RESOURCE CONSERVATION AND RECOVERY ACT FACILITY INVESTIGATION REPORT
ADDENDUM AREA OF CONCERN 558 (AOC 558) ZONE E CNC CHARLESTON SC
7/2/2002
CH2M HILL

RFI REPORT ADDENDUM

Area of Concern 558, Zone E

Re: RFI Report Addendum (Revision 0) – AOC 558, Zone E

FIGURE 10.28.1
WIPE SAMPLE LOCATIONS
AOC #558
SUBSTATION
BUILDING 77

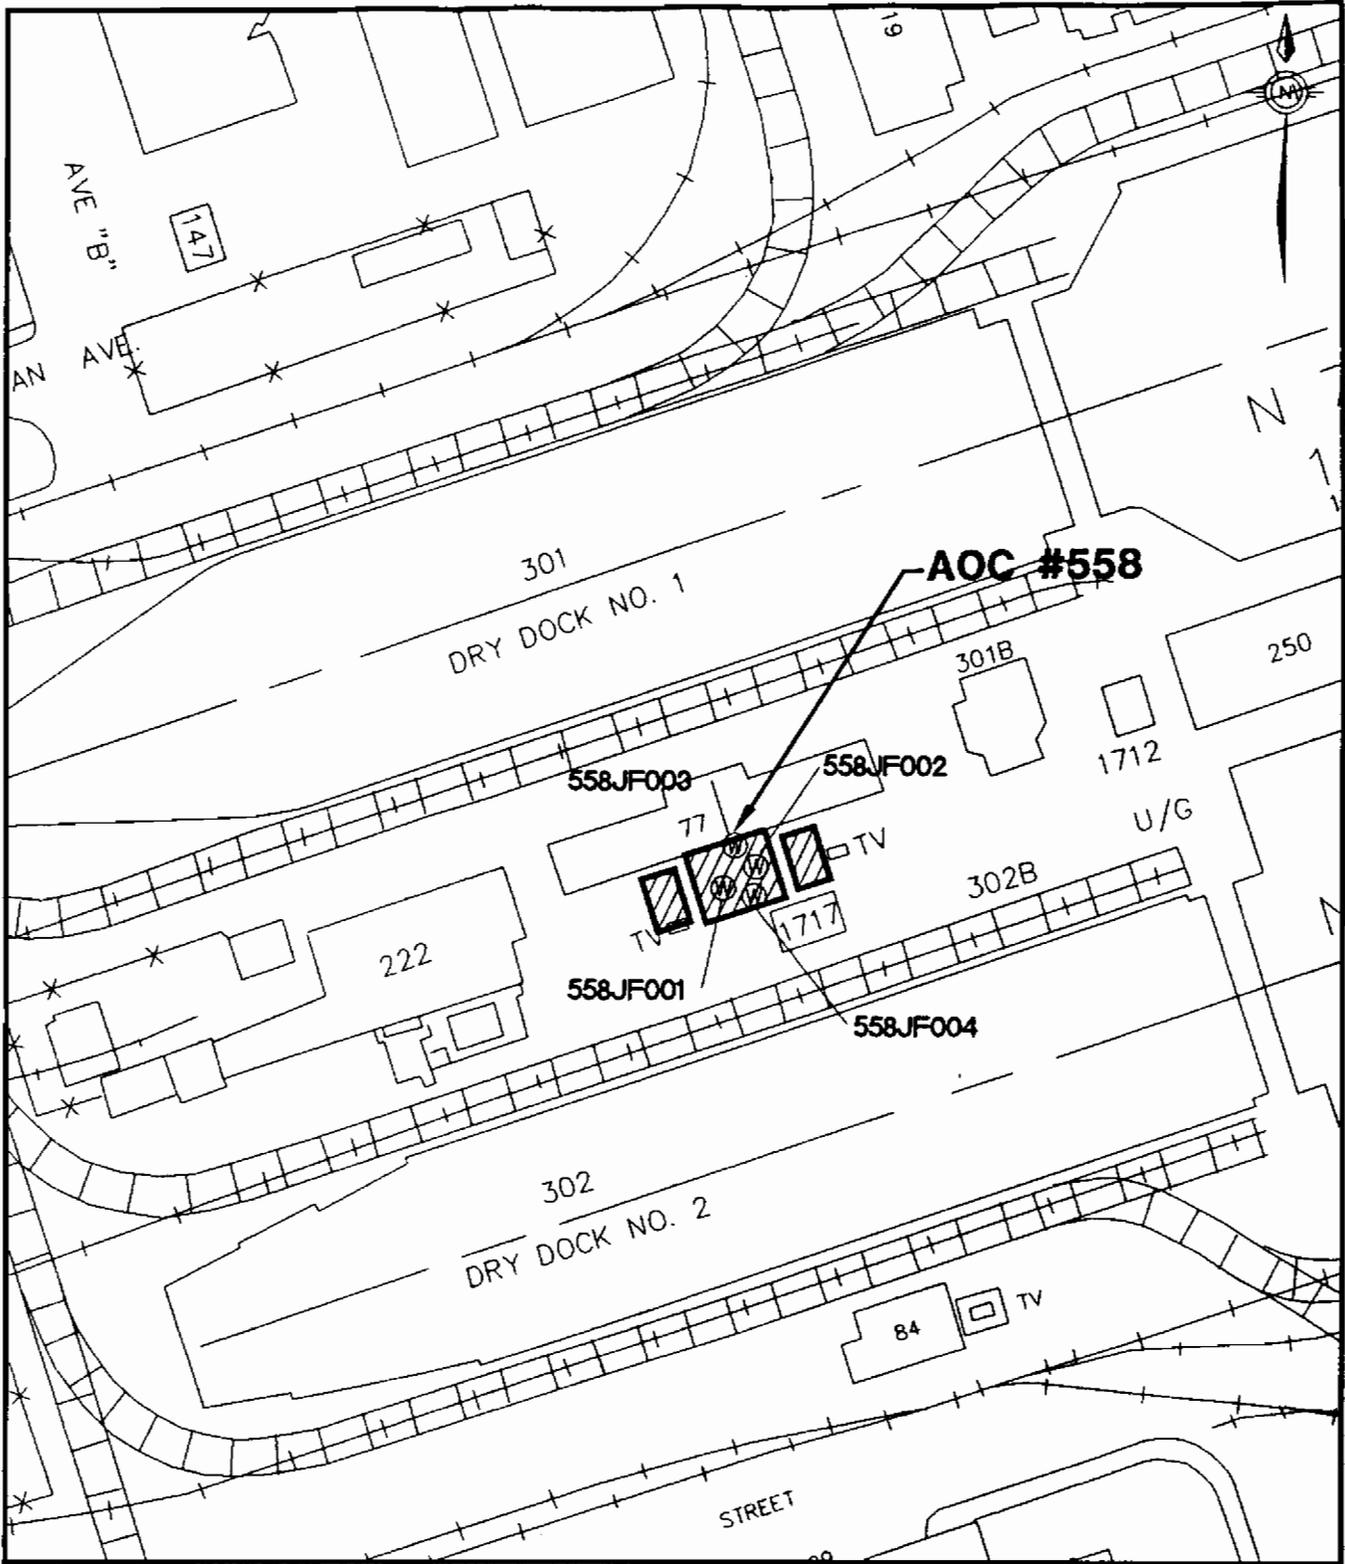
The Navy should collect soil samples around building 77 for DQO Level III for the standard suite of parameters which includes VOCs, SVOCs, pesticides/PCBs, metals, and cyanides.

An attempt will be made to collect soil samples from around Building 77 for the standard suite of parameters.

The RFA for AOC 558 recommended the site for a Confirmatory Sampling Investigation. The Final Zone E RFI Work Plan recommended four wipe samples and four concrete core samples to fulfill the CSI objectives. During the review of the Zone E RFI WP, submitted on June 2, 1995, SCDHEC provided a single comment related to AOC 558, which focused on possible collection of sediment samples in the event that the wipe samples or concrete core samples identified COPCs. Thus, SCDHEC concurred with the proposed scope of sampling at AOC 558 to meet the CSI objectives.

The wipe and concrete core samples proposed in the RFI WP were collected and analyzed per the work plan. Based on the results from the wipe samples and concrete core samples, the RFI did not identify any COPCs or COCs. Thus the objectives of the confirmatory sampling were met. Therefore further investigation at this site is not warranted.

FIGURE 10.28.2
CONCRETE SAMPLE LOCATIONS
AOC #558
SUBSTATION
BUILDING 77

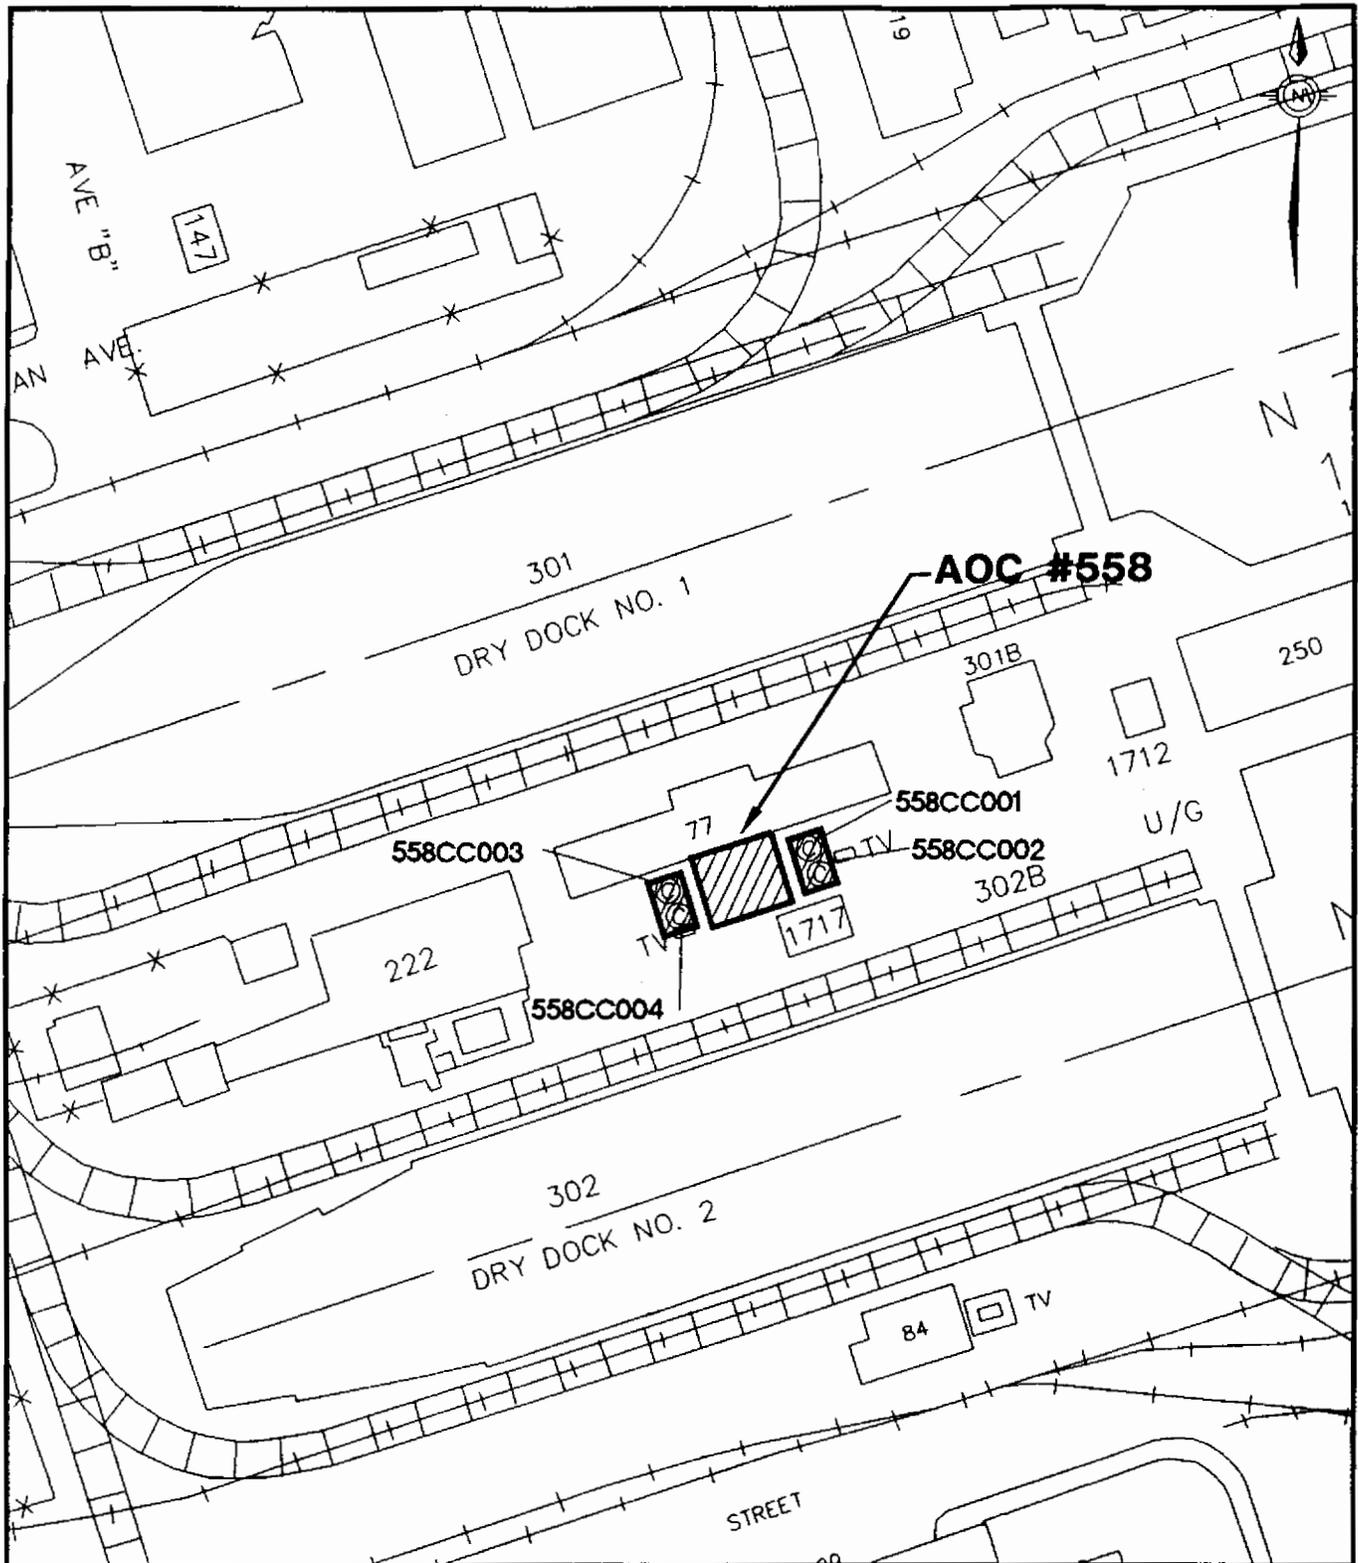
An explanation is needed as to why concrete core samples were not collected in the middle of the building.

Concrete samples were collected from the concrete pads associated with the switchgear located outside the building to investigate possible releases of dielectric fluid. Wipe samples were collected from the several areas within the transformer vault and included any stained areas inside the building to detect any possible migration pathway of released dielectric fluid.

No additional comment needed.
